Wisconsin Department of Transportation

Proposal #01: 1003-10-79, WISC 2018 280
Illinois State Line - Madison
IH 43 Interchange
New Alignment
IH 39
Rock County

This is Addendum No. 04, which provides for the following:

ADDENDUM NO. 04
1003-10-79 & 1003-11-71
June 7, 2018

GENERAL NOTES AND QUANTITIES SHEET 3 OF 30
904

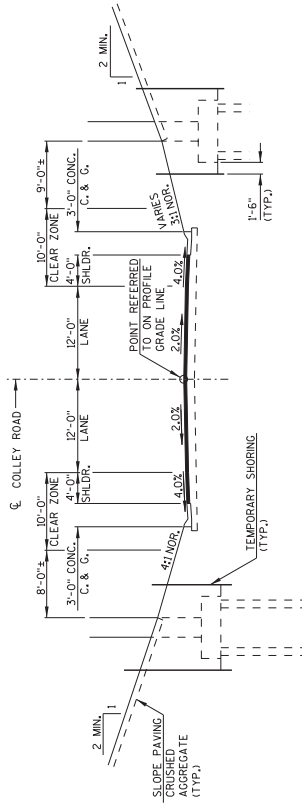
Revised Plan Sheets	
Plan Sheet	Plan Sheet Title (brief description of changes to sheet)
	Project ID 1003-11-71
904	Structure B-53-216 (Quantity Update)

NO.	DATE	REVISION	CONTAINMENT BID ITEM	MES
1	6/7/18

517.6001	CONTAINMENT AND COLLECTION OF WASTE MATERIALS B-53-216	LS					1
517.6001.5	PORTABLE DECONTAMINATION FACILITY	EACH					1
550.1100	PILENG STEEL HP 10-INCH X 42 LB	LF	280	595	280	1,155	1,685
